# Staff Report

To: Salt Lake City Planning Commission  
From: Nannette Larsen, Principal Planner, 385-386-2761 or [nannette.larsen@slcgov.com](mailto:nannette.larsen@slcgov.com)  
Date: October 14, 2020  
Re: PLNPCM2020-00439 – 800 S + State Street Design Review

## 800 S + STATE STREET – DESIGN REVIEW

21A.37.050.D BUILDING ENTRIES

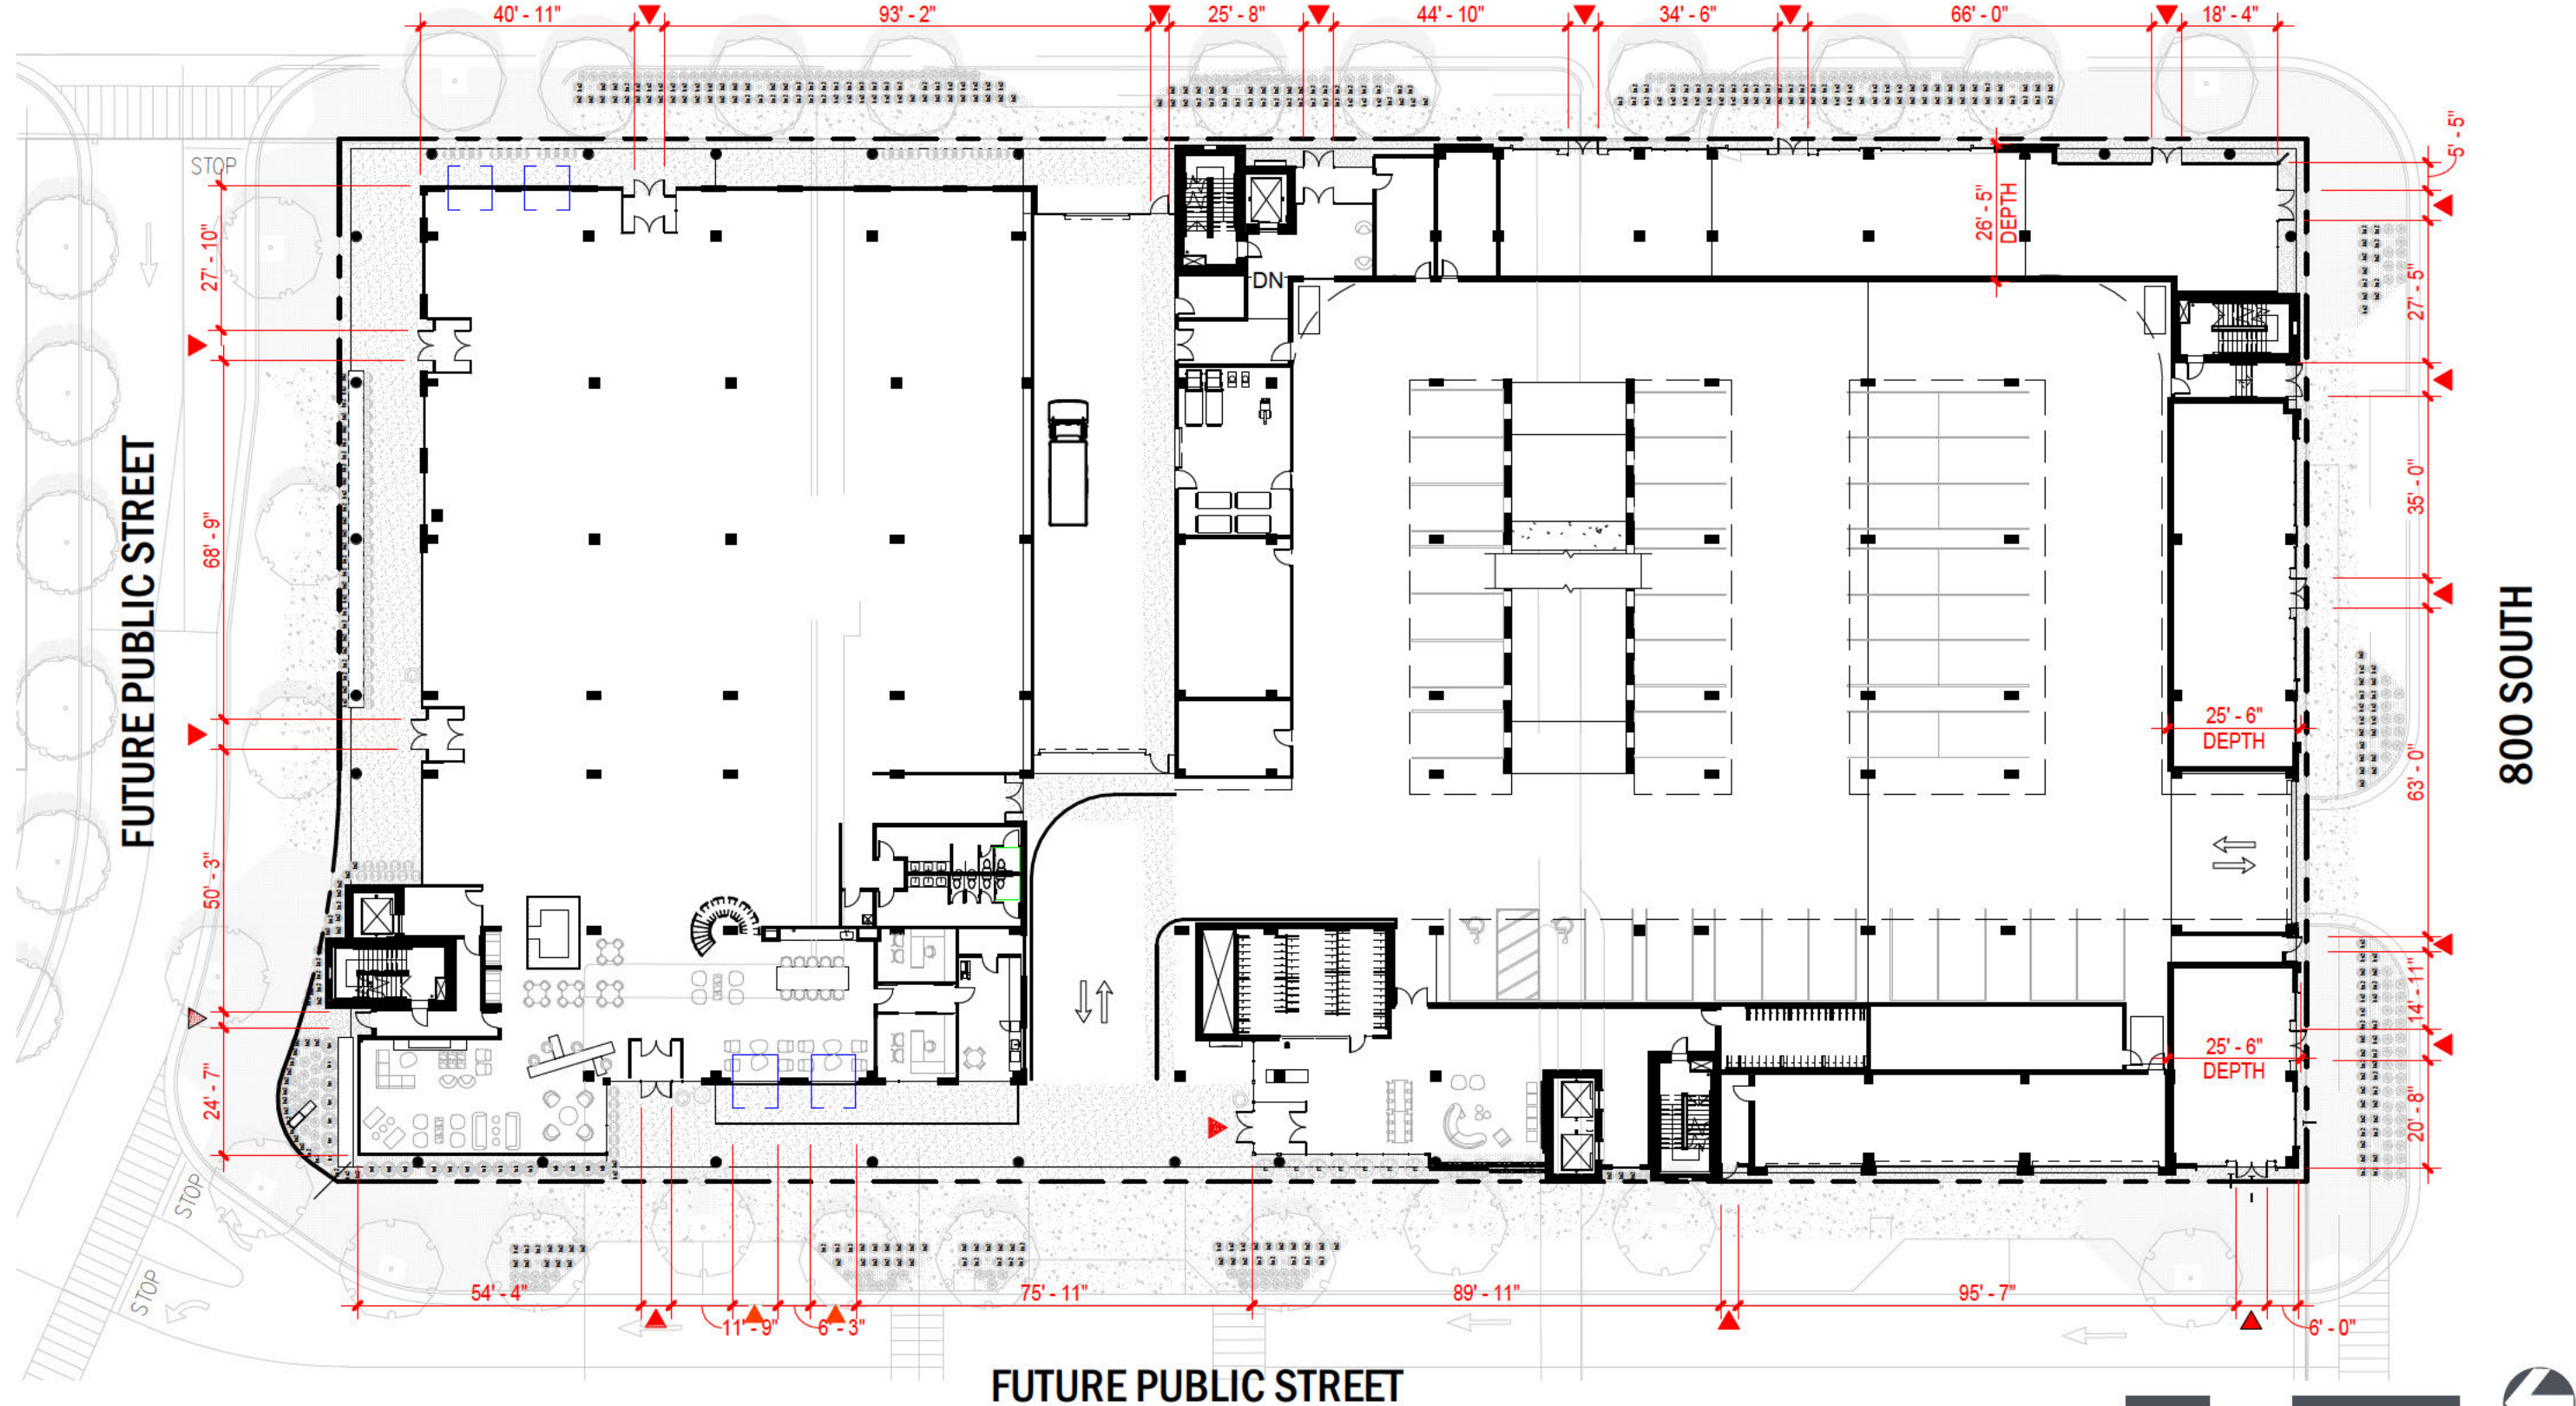
The intent of the Design Review Standards are being met as it relates to building entrances. This is facilitated by the parking lot located in the interior of the building, the window to wall ratio greater than the underlying standards, and the proposed project interacts with the sidewalk through seating areas and a colonnade. Planning Staff recommends allowing for a modification to the building entrance design standards.

21A.37.050.F MAXIMUM LENGTH OF STREET FACING FACADE  
21A.30.030.D MAXIMUM BUILDING HEIGHT

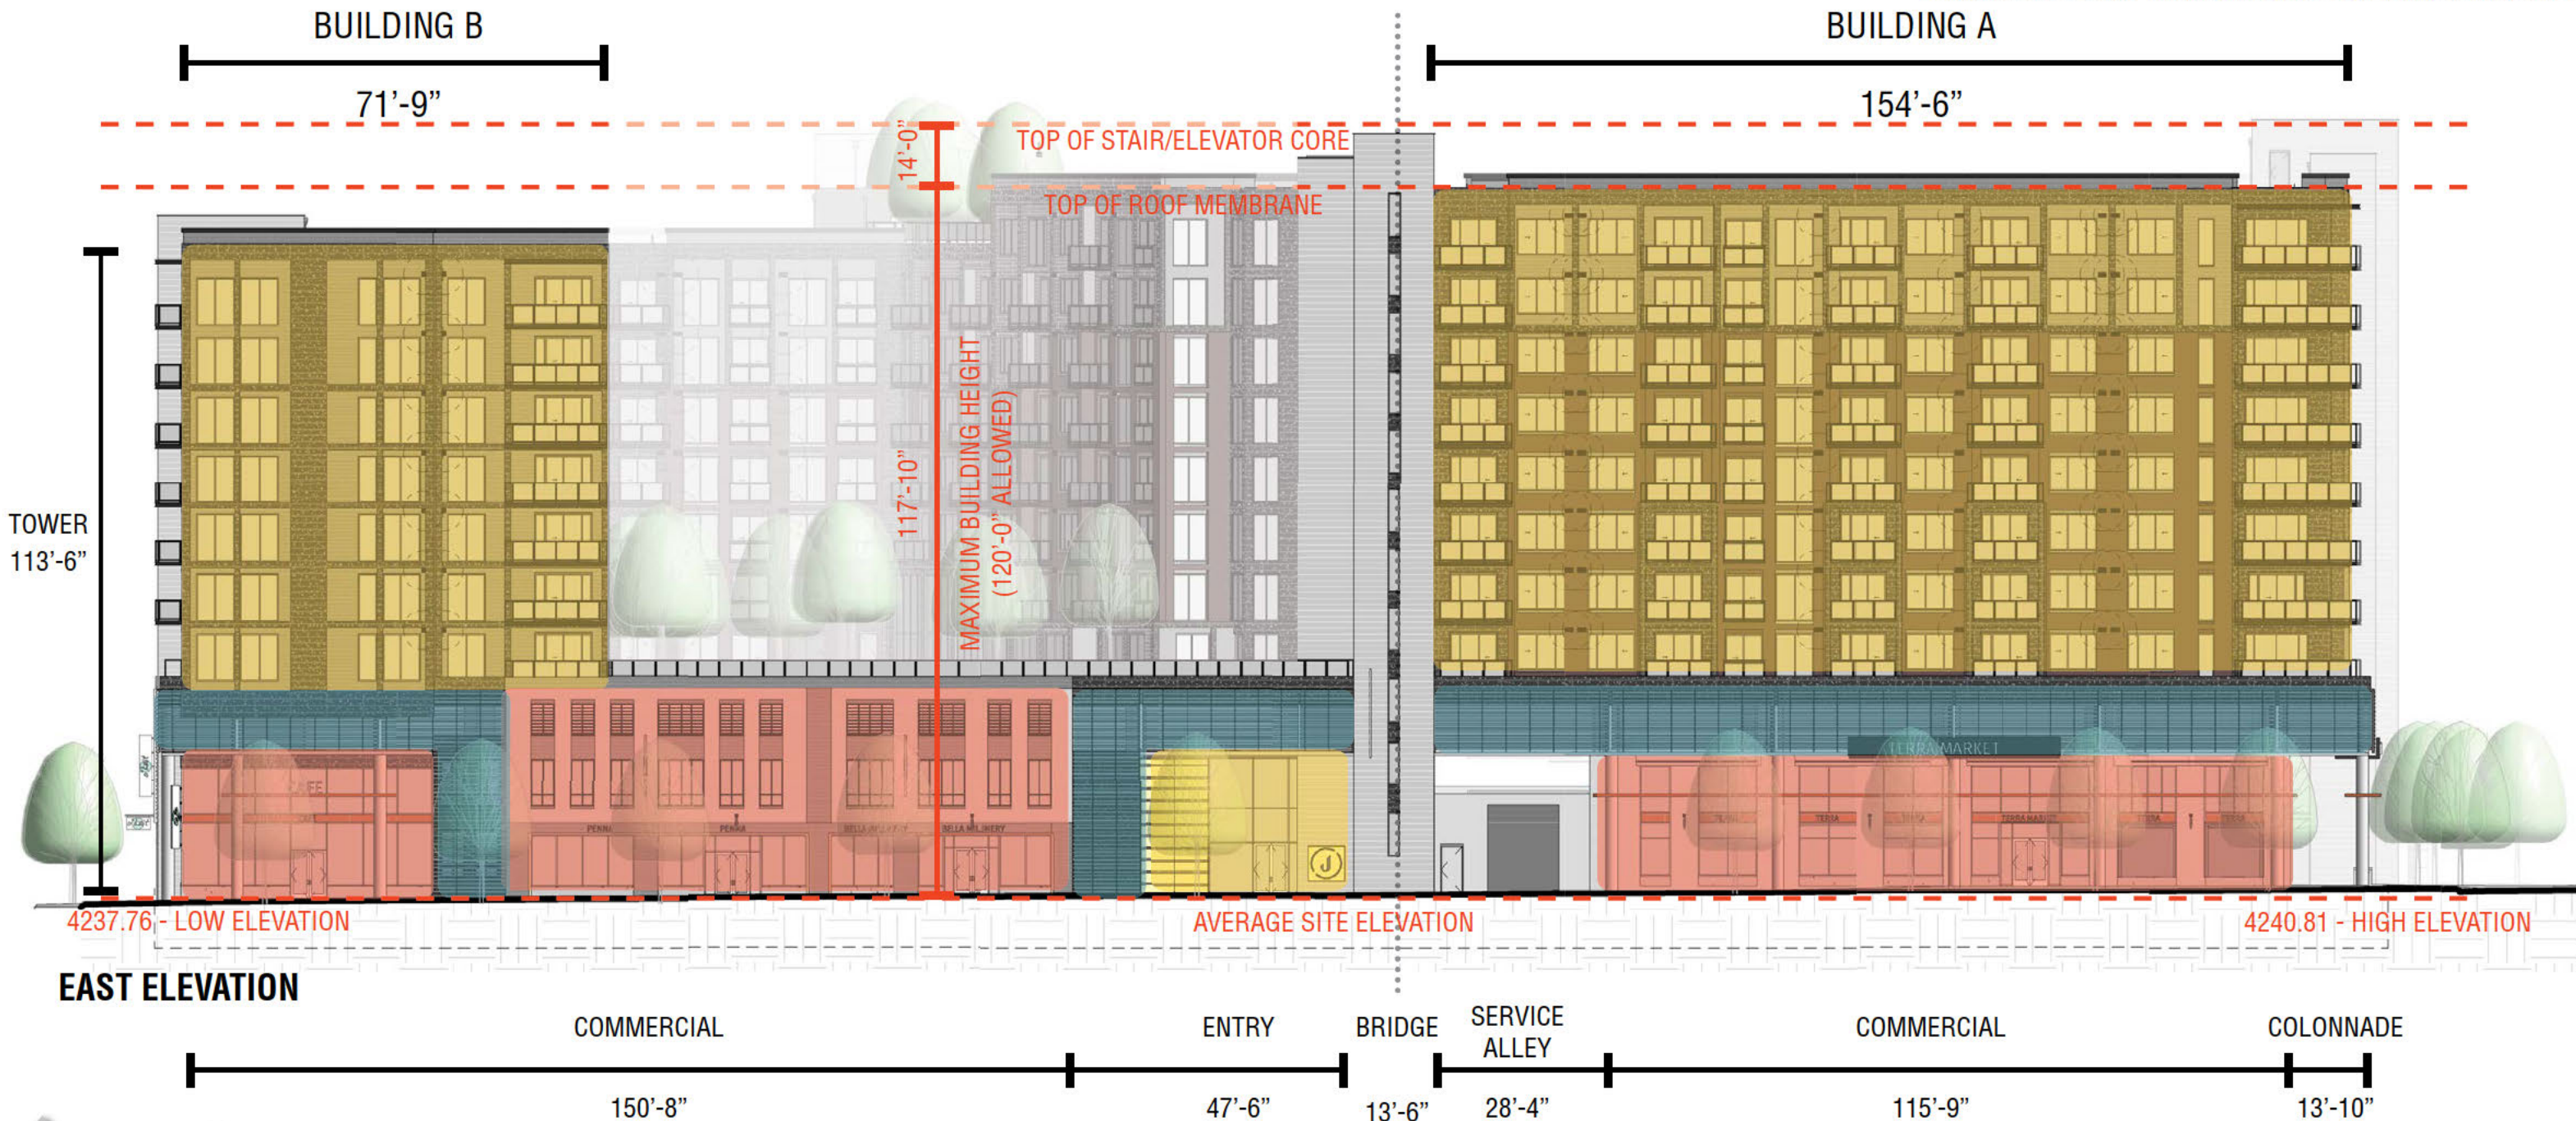
The maximum allowed length of a street facing façade in the D-2 zoning district is 200’. The 800 S + State building is proposed to have a total length of approximately 196’ on the north and south facades, which face 800 South and a proposed new street to the north, and will have approximately 373’ along State Street to the East, and a proposed new street, Major Street, to the West. The east and west façades require a Design Review by the Planning Commission prior to approval as the facades exceed the maximum length.

The 800 S + State Street will meet all three of these requirements as reviewed in Key Consideration 1 section of this report. The upper floor step back and material changes from the lower ground floors and the upper building floors will allow for changes in the vertical plans of the building and encourages the perception of different pedestrian experience along the length of the building. Differing massing changes are also proposed between the northern and southern portions of the building it also creates a different perception of the building as a mitigating factor to the excess façade length.
